T. W. Quigley  
Environmental Project Leader  
Sand Rock Mill  
Minerals Department

Re: Replacement Pages for Sections 2.10 and 5.1 of the Sand Rock Mill  
ER - NRC Docket No. 40-8743

**SAND ROCK MILL PROJECT**  
**CAMPBELL COUNTY, WYOMING**

**FIGURE 2.10-4**  
**AIRBORNE PARTICULATE**  
**CONCENTRATIONS<sup>(1)</sup>**

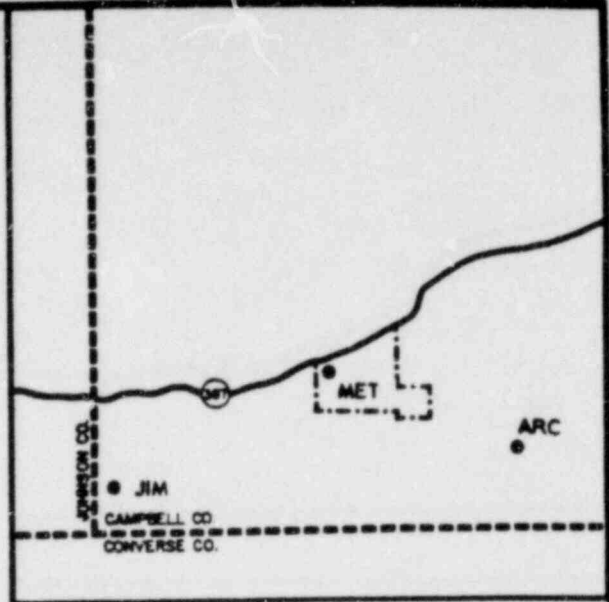
1. Pages 2-237 and 2-238 of Section 2.10 have been corrected to show the proper units for the air particulate data. Also, additional data has been included which was not available in July 1980.
2. Table 5.1-4 (page 5-18) has been revised to reflect the ranges of the complete data set which are shown in 1 above.
3. Figure 2.10-7 (page 2-252) has been revised to show the gamma measurements which were taken at the radiological monitoring stations where radon and air particulate data was collected.

FIGURE 5.1-7  
 TOTAL AIR CONCENTRATION OF PARTICULATES

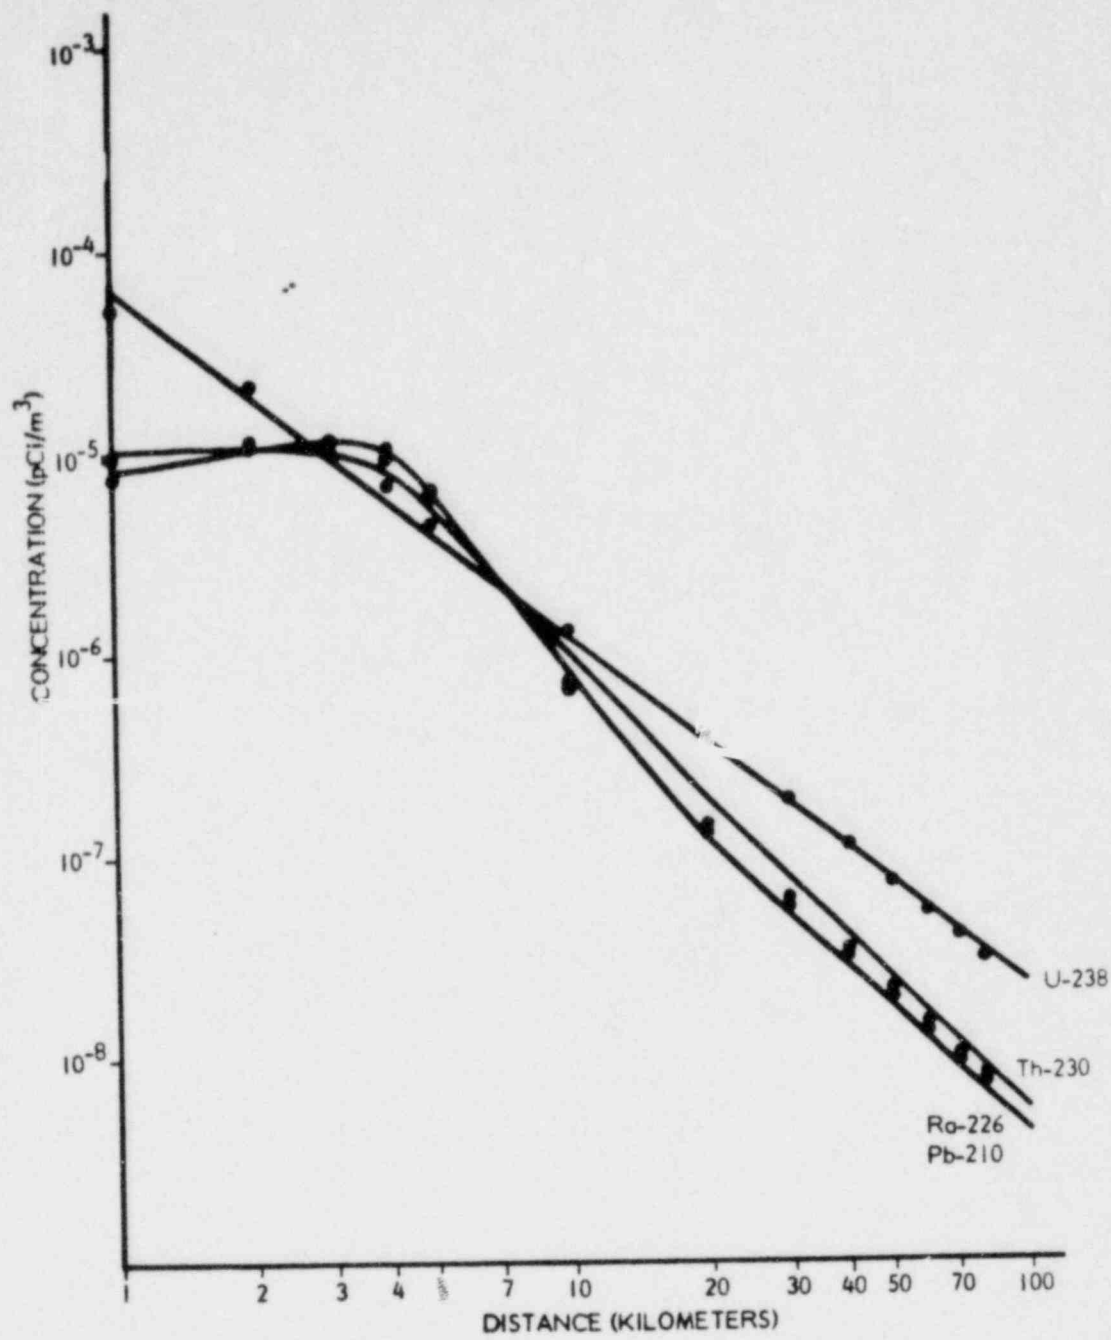
NOTE: Revision reflects addition of data to Figures 2.10-3 and 2.10-4.

| FIGURE 2.10-7  |            |           |             |

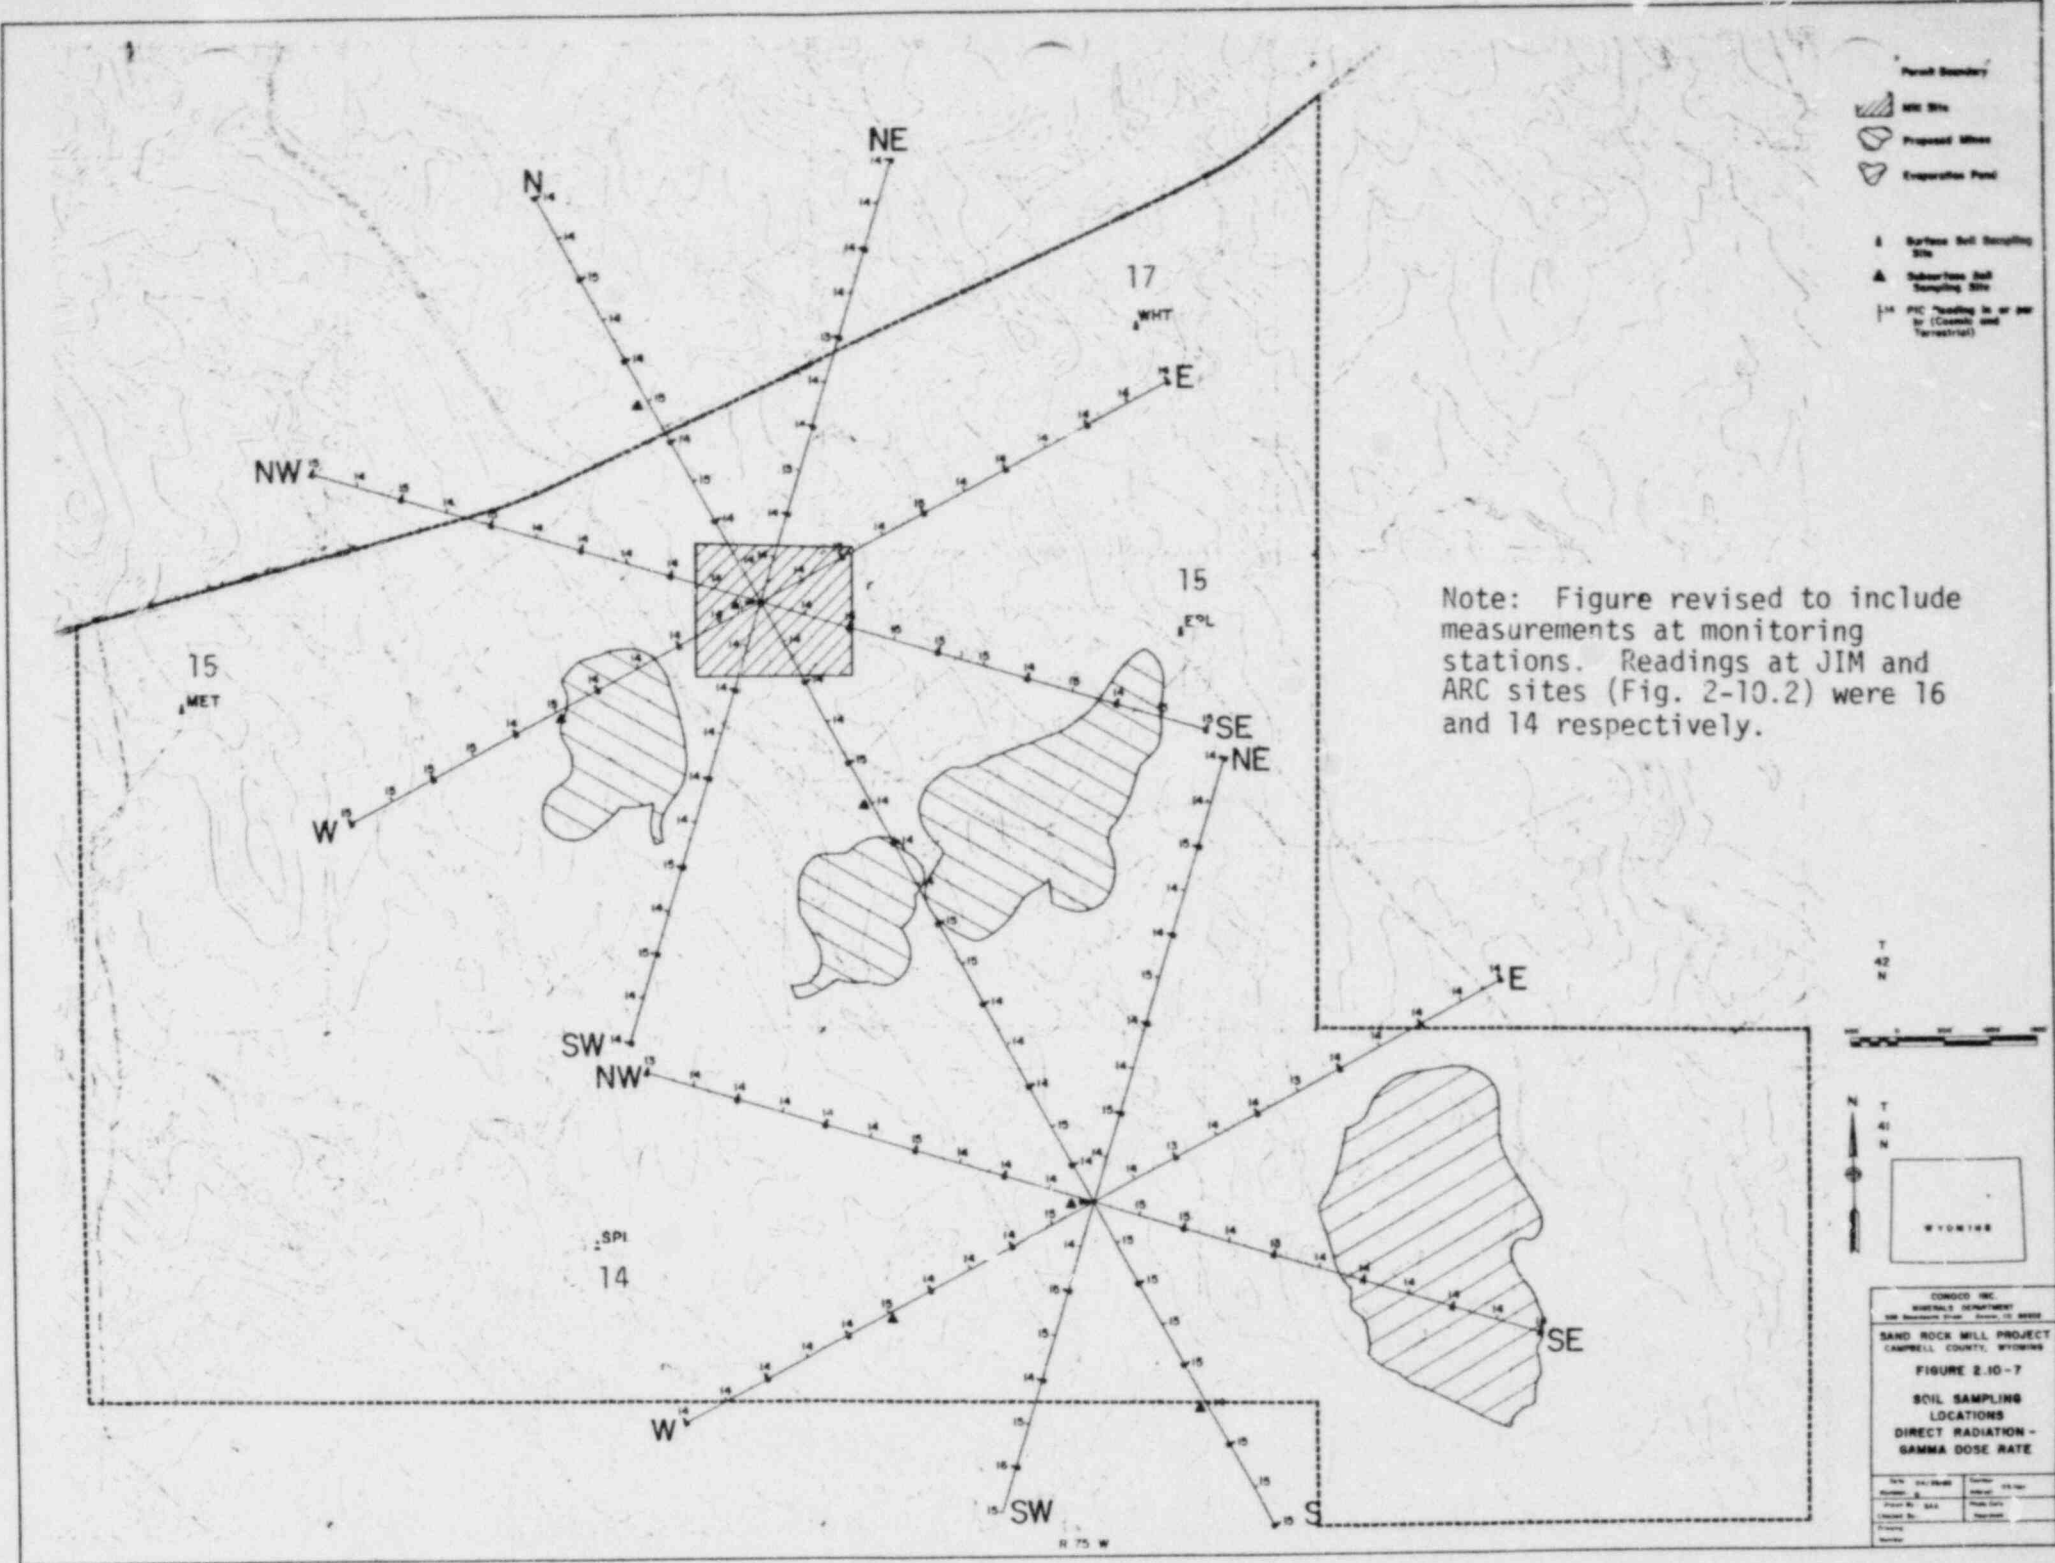
Note: Figure revised to include measurements at monitoring stations. Readings at JIM and ARC sites (Fig. 2-10.2) were 16 and 14 respectively.
